Subject: Legistar #77016, in support of protecting Isthmus Path Prairie Garden

Plan Commission Meeting of May 8, 2023 Agenda item #15, Legistar #77016

Respectfully Submitted, Linda Lehnertz Plan Commission Meeting of May 8, 2023 Agenda #15, Legistar #77016

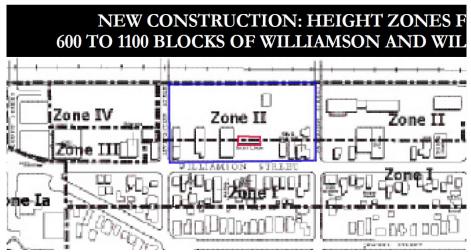
The two 5-story buildings cited as precedence in the staff report are in a different BUILD II height category. Those buildings are in "Zone IV" while 302 S Paterson would be in "Zone II."

- Zone IV permits a 5-story/54' building, with additional bonus floors (for affordable housing, preservation or structured parking) not to exceed 85' in height from the street grade or 7 floors, whichever is less. The building at the back of 722 Williamson is 55.25' in height (159.8' to the top of the screen wall), but that building also involved the preservation of the Olds Building and structured parking. The 302 S Livingston building is 60 feet, and was also entitled to the structured parking bonus.
- Zone II permits a 3-story building with one potential bonus story for affordable housing, preservation or structured parking.

The context of the 700 and 800 blocks differs.

- The 700 block backs up to MG&E's Blount Street generating station, a more industrial area with massive buildings one-half block away.
- The 800 block backs up to a block that is primarily an MG&E equipment storage lot, and a 2-story water utility office. The largest building on that block is at the furthest corner, a 4story parking garage.
- The properties along the bike path on the 700 block are all large buildings. The properties along the 700 block of Williamson were all commercial uses, though new construction has resulted in two mixed-use properties.
- 302's immediate neighbor along the bike path is a 3-story apartment building. The properties at the northeast corner along Williamson are a 2-unit and a 4-unit (both 2 stories), a 3-story tavern at the corner with 13 units, and a 1½ story tavern.
